[Docket No. FAA–2010–1101; Directorate Identifier 2009–CE–013–AD; Amendment 39–16690; AD 2011–10–09]

Airworthiness Directives; Cessna Aircraft Company Models 150, 152, 170, 172, 175, 177, 180, 182, 185, 188, 190, 195, 206, 207, 210, T303, 336, and 337 Airplanes

ACTION: Final rule.

Figure 1. Diameter of seat pin locking engagement hole

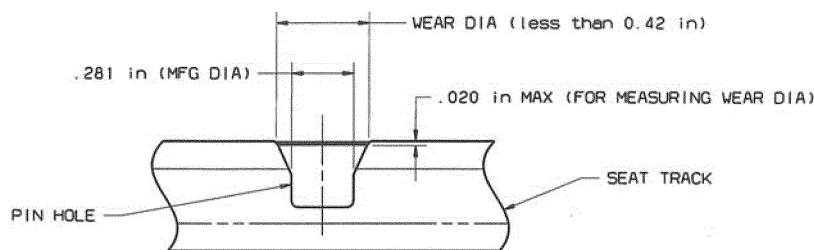
Dave McFarlane requested we add a maximum allowable incremental 0.07-inch radius dimension to figure 1 at the outside diameter dimensions for clarification.

We disagree with this comment. The measurement dimensions in figure 1 adequately address the measurements necessary for this AD. Additional measurements will not provide any additional benefit.

We have not changed this final rule AD action based on this comment.

Figure 4. Closeup of seat roller housing and tang gap width

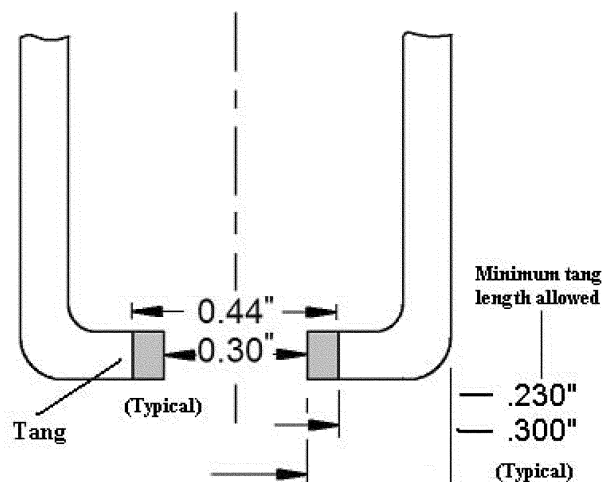
Brian A. Andrus, Jim Currie, and Jerry Unruh requested we change the tang measurement to the outside of the seat roller housing and change the description of the tang measurement. This change would make it easier for the inspector to take the measurement and to better understand what is being measured.

We agree with this comment. We agree that measuring the tang length inside of the roller housing is difficult because of the presence of the rollers inside of the roller housing.

We have changed the callouts in figure 4 to measure the tang length from outside of the roller housing instead of from inside of the roller housing. We have also changed the description of the tang measurement in figure 4 to more accurately describe the measurement.
